Access Compliance Report

Public Rights-of-Way

(Curb Ramps)

Intersection ID: 44347	Main Street: CHOATE_CR	Cross Street: STONE_ARBOR_WY	Location: NE
ADA ID: 5EA4678FF178	Ramp Type: PerpDiag	Initial Pass/Fail: Fail	Overall Compliance: No
Severity Score: 25			
Codes/Mitigation Info/Possible Solution		Field Measurements/Component Compliance

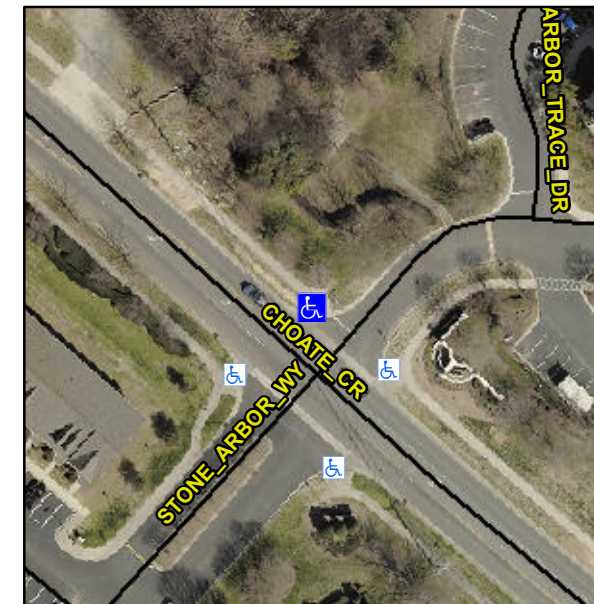
Not Found, R304.2.2

Compliance	Description	Data	Compliance	Description	Data
N/A	Ramp Length (in)	96.0	No	Ramp Slope (%)	12.0
Yes	Ramp Width (in)	49.0	Yes	Ramp XSlope (%)	0.3
N/A	Flare Type LT	N/A	N/A	Flare Type RT	N/A
N/A	Flare Slope LT (%)	N/A	N/A	Flare Slope RT (%)	N/A
N/A	Flare Traversable LT?	N/A	N/A	Flare Traversable RT?	N/A
N/A	Landing Length (in)	N/A	N/A	DWS Provided?	N/A
N/A	Landing Width (in)	N/A	N/A	DWS Contrast?	N/A
N/A	Landing Slope (%)	N/A	N/A	DWS Length (in)	N/A
N/A	Landing X Slope (%)	N/A	N/A	DWS Full Width?	N/A
N/A	Landing Curb? (Y/N)	N/A	N/A	DWS Offset (in)	N/A
N/A	Shared Landing?	N/A			
N/A	Gutter Ponding?	N/A	N/A	Gutter Slope (%)	N/A
N/A	Gutter Lip Ht (in)	N/A	N/A	Gutter X Slope (%)	N/A
N/A	Painted X Walk1?	No	N/A	Painted X Walk2?	No
	X Walk 1 Direction	To SW		X Walk 2 Direction	To SE
N/A	X Walk 1 Width (in)	N/A	N/A	X Walk 2 Width (in)	N/A
	X Walk 1 Slope (%)	3.6		X Walk 2 Slope (%)	0.5
	X Walk 1 X Slope (%)	1.0		X Walk 2 X Slope (%)	0.9

Remove & Replace Curb Ramp With Two New Directional Ramps or Equivalent.
